Subject: PASSENGER SIDE FOOTWELL AREA TOO HOT FROM HEAT RADIATED BY HEATER CORE	Bulletin No: 07-001/16
	Last Issued: 02/23/2016

2016 MX-5 vehicles with VINs lower than JM1ND*****108888 (produced before December 16, 2015)

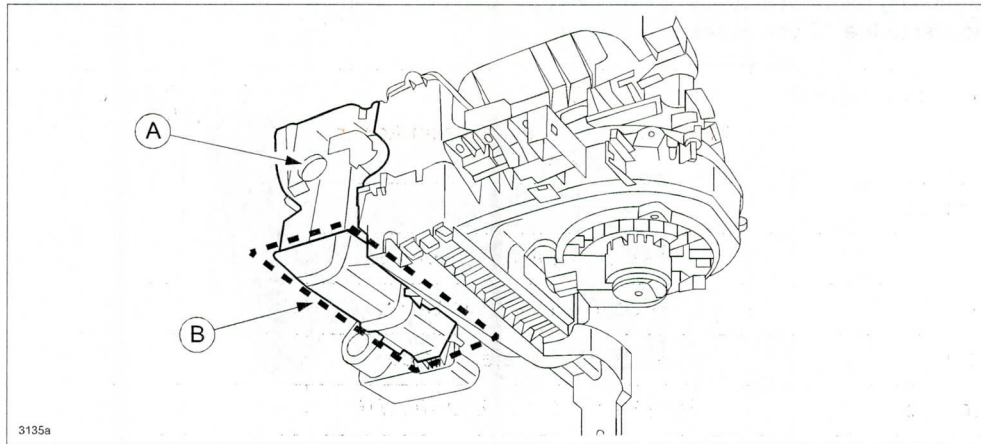
Some customers may complain that the temperature is too hot around the passenger side footwell area. This concern is due to heat radiated directly from the heater core (A) to this area. To correct this problem, a heat insulator (urethane sheet) is now attached to the under part of the heater core (B) to decrease the surface temperature.

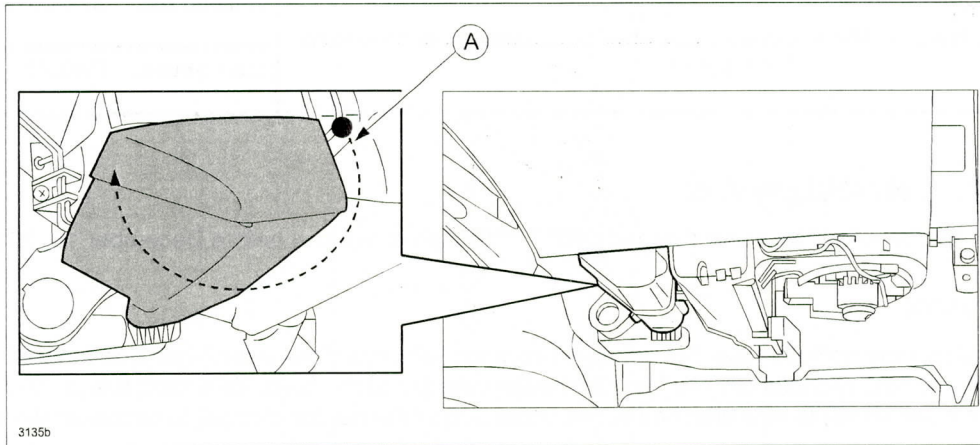
NOTE: In the following graphics, the heater core unit is removed from a vehicle and placed upside down for viewing purpose only. It is not necessary to remove it for the actual repair. The work can be done by accessing the heater core unit from passenger side footwell without removing any surrounding parts.

2. Attach the insulator starting from point (A).

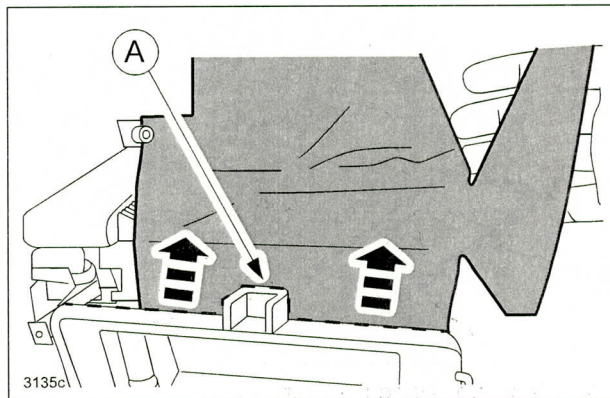
- a. Start attaching the heat insulator by aligning the one edge with the cutout portion (A) to the heater core unit closest to the 12 volt accessory socket.

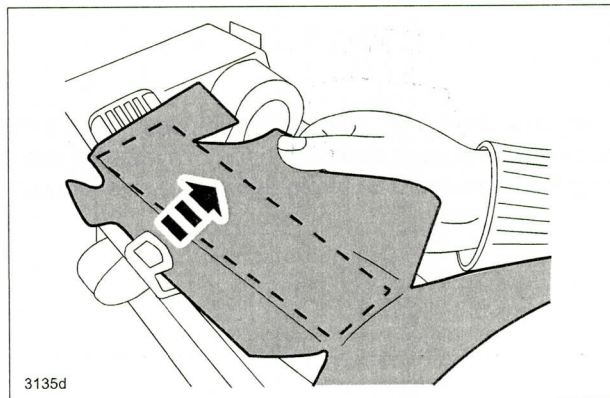
- b. Attach the heat insulator to the top surface of the heater core unit (without any wrinkles).

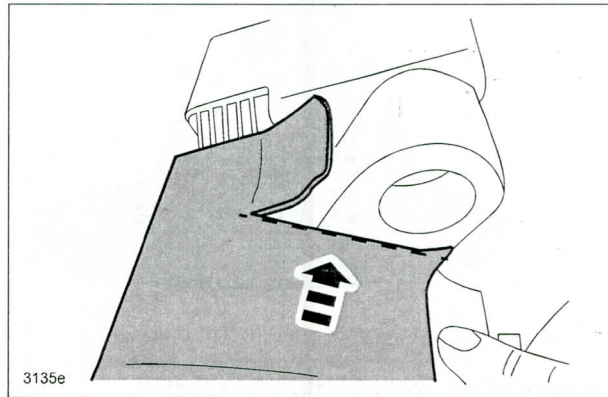
- c. Attach the edge of the heat insulator (without any clearance) by aligning it with the shape of the heater core unit.

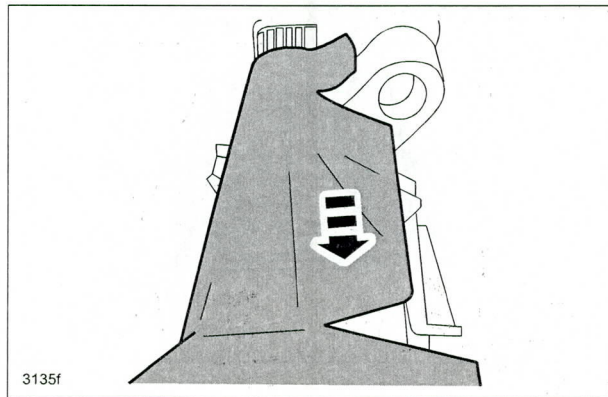
- d. Attach the heat insulator as shown.

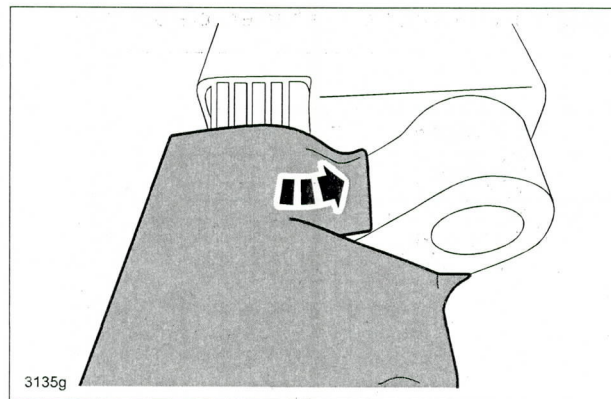
- e. Attach the edge of the heat insulator along the round shape.

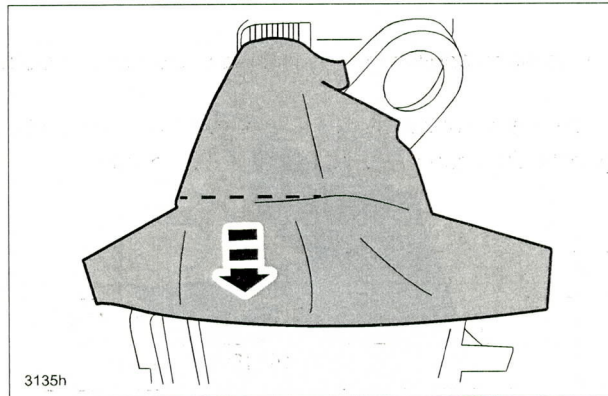
- f. Fold the heat insulator over the edge and attach.

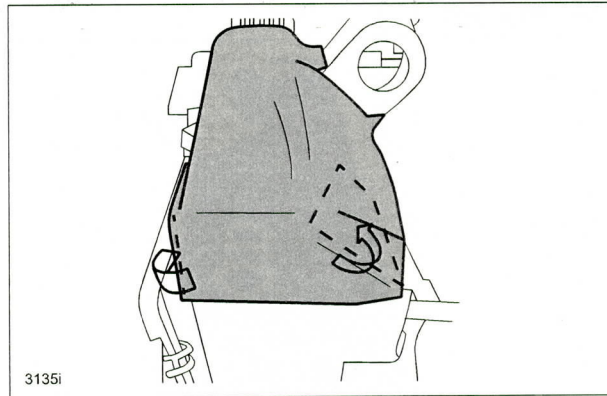
- g. Fold over the edge portions of the heat insulator and attach.
